DRAWINGS – REVISION 1

DMVA PROJECT NO. 42230136 For BUILDING 16-153 RENOVATION

'REVISION 1' includes the following drawing sheets and notes.

POWER & SIGNAL		
CONTRACTOR SHALL FIELD VERIFY ALL DIMENSIONS. VARIANCE FROM CONTRACT DOCUMENTS NOT PERMITTED WITHOUT BUREAU OF ENGINEERING AND ARCHITECTURE APPROVAL.	DRAWN BY B. BARGER	DATE 15 MAR 2024
	CHECKED BY D. HEALEY	SCALE AS NOTED
	DRAWING NO. E.1.2

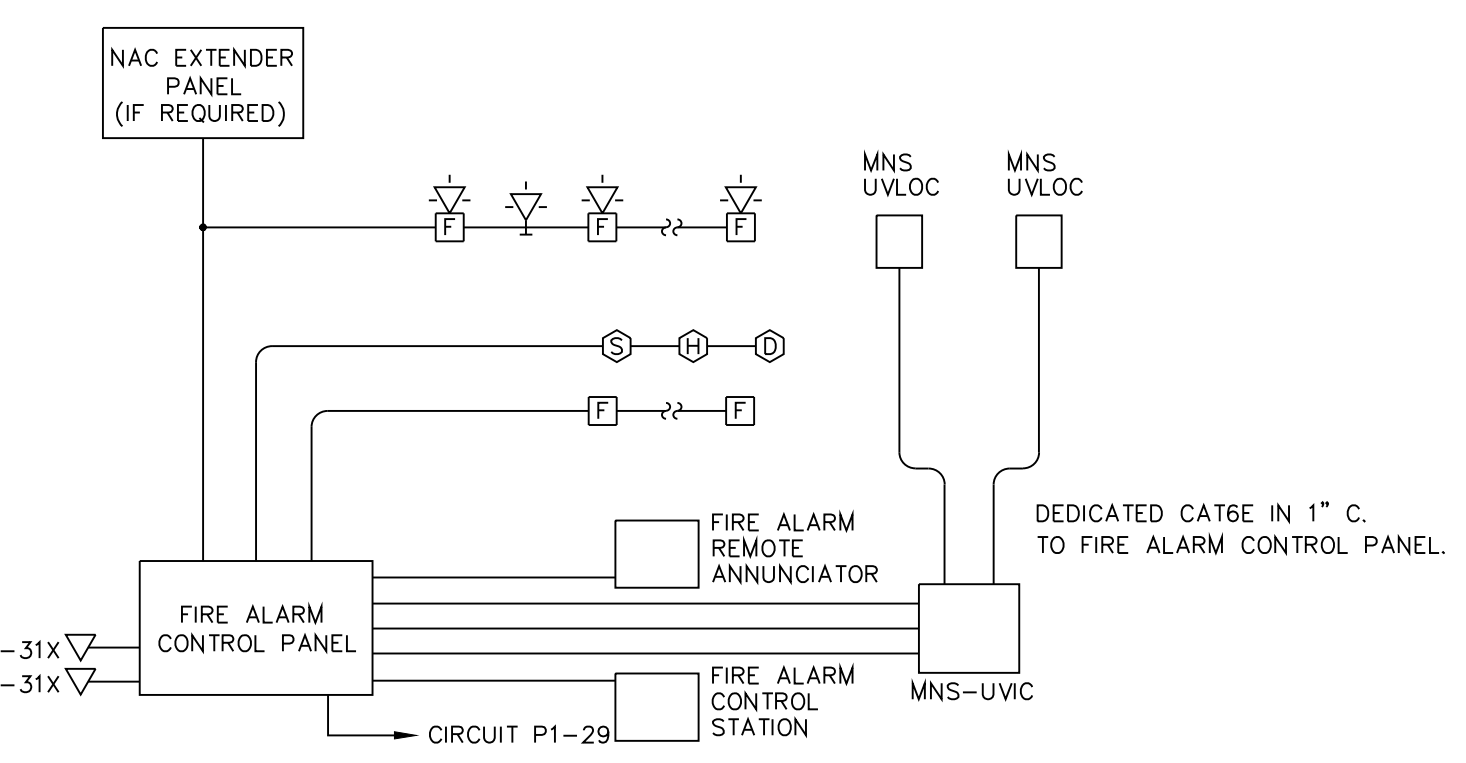
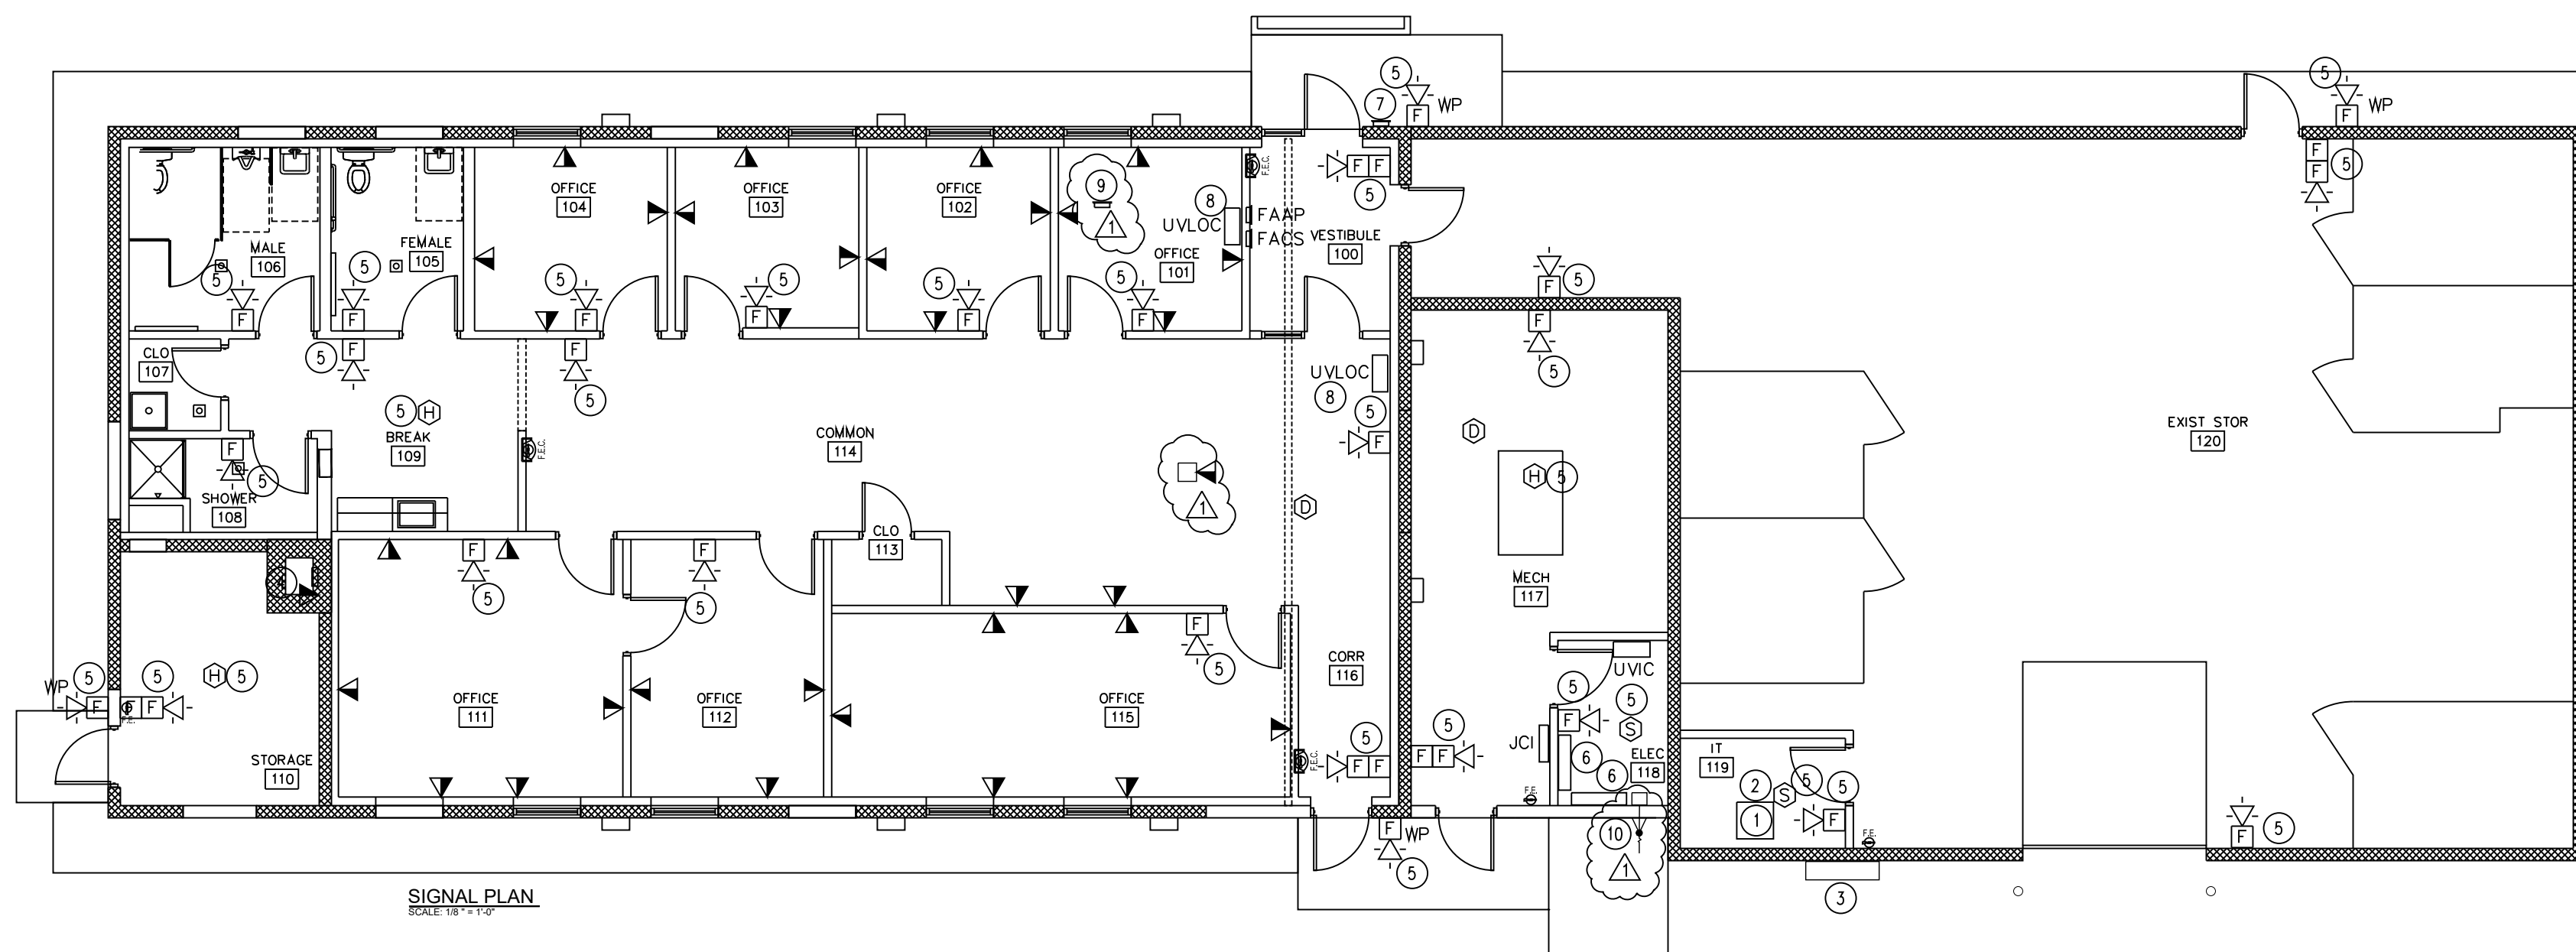
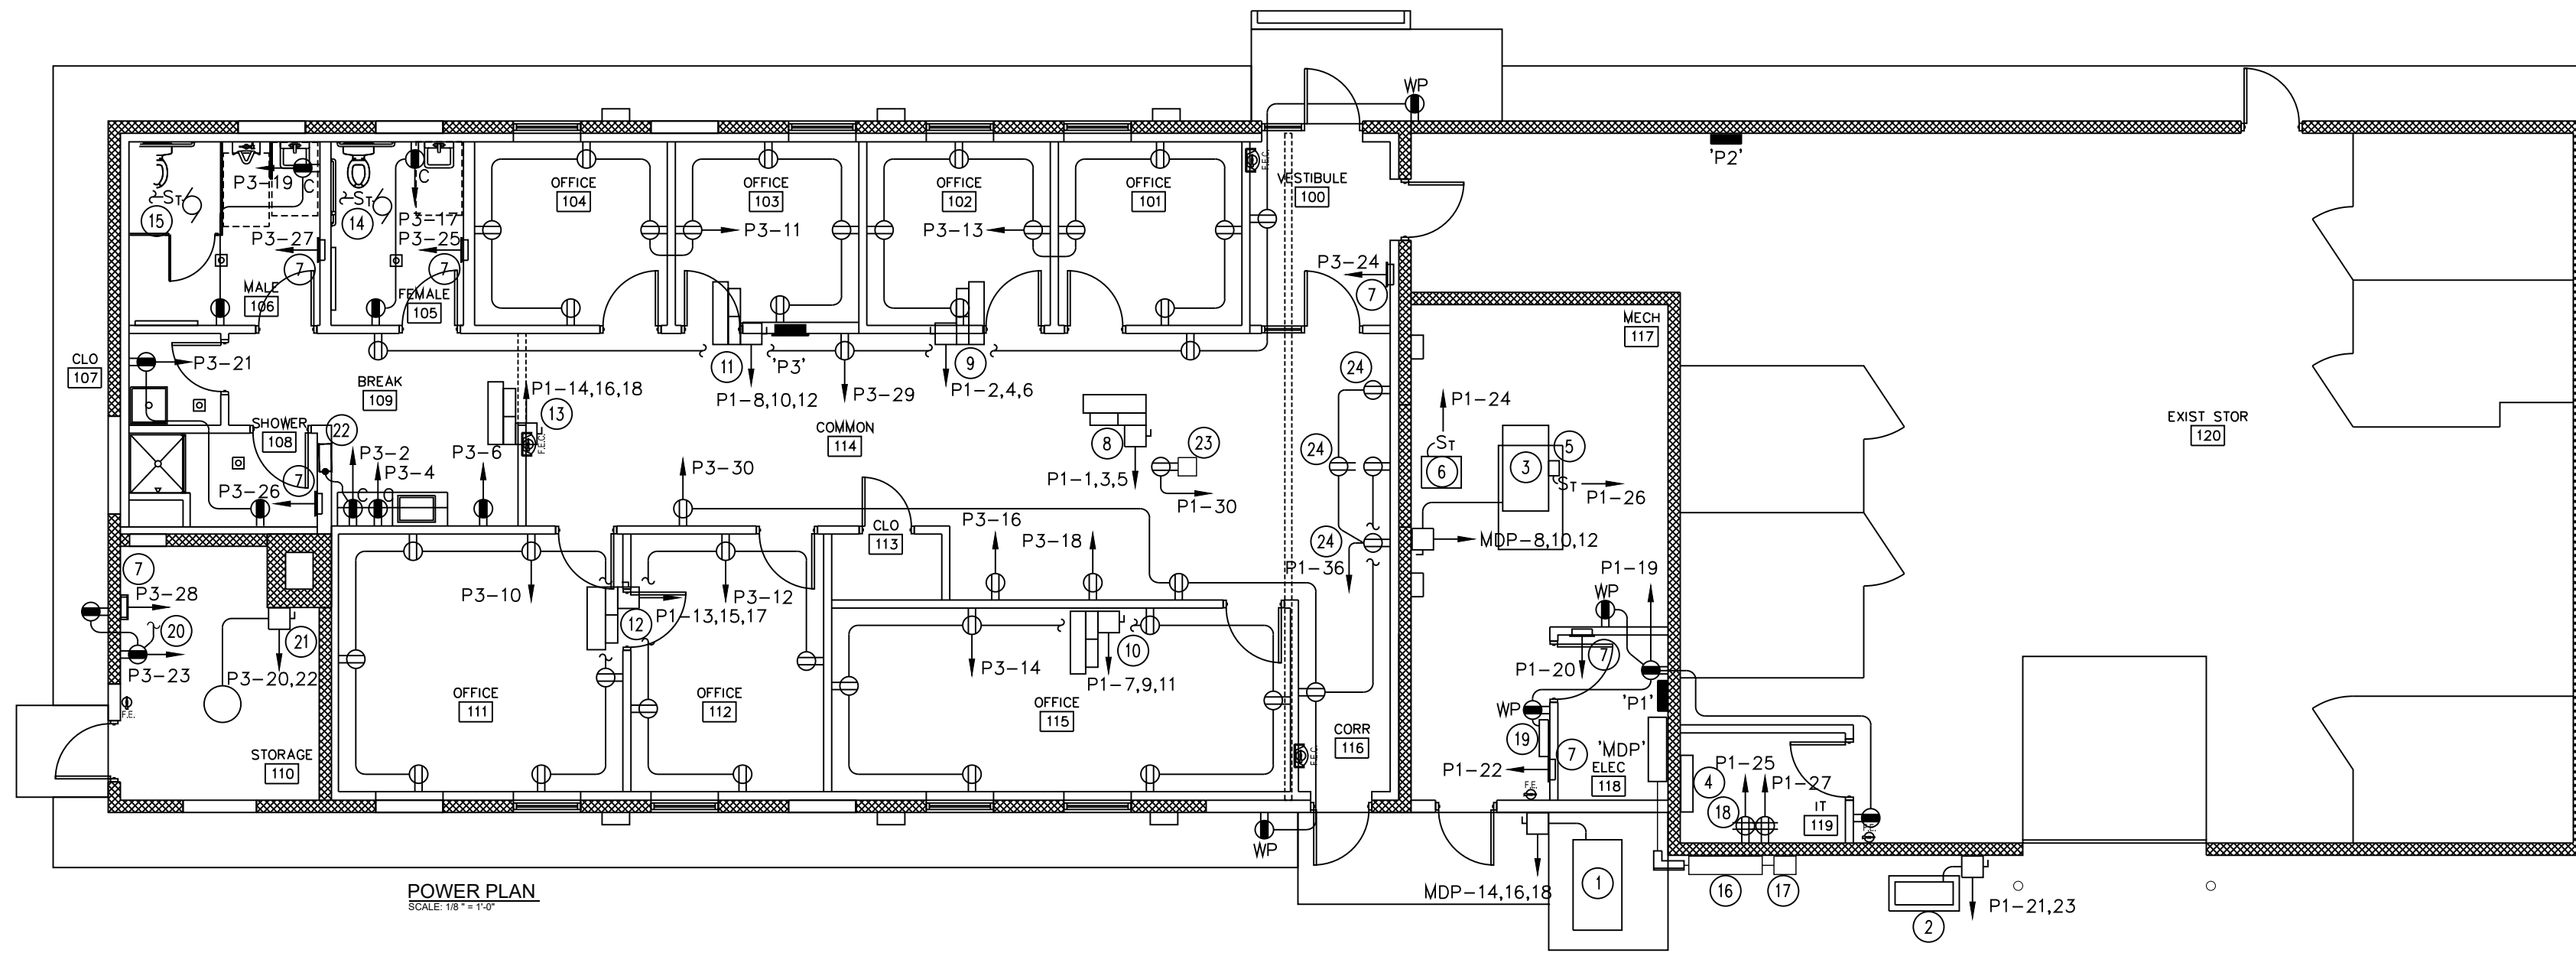
NO.	DESCRIPTION	DATE
1	ADDED AIPHONE DESK UNIT - CLARIFICATIONS	5 APR 24
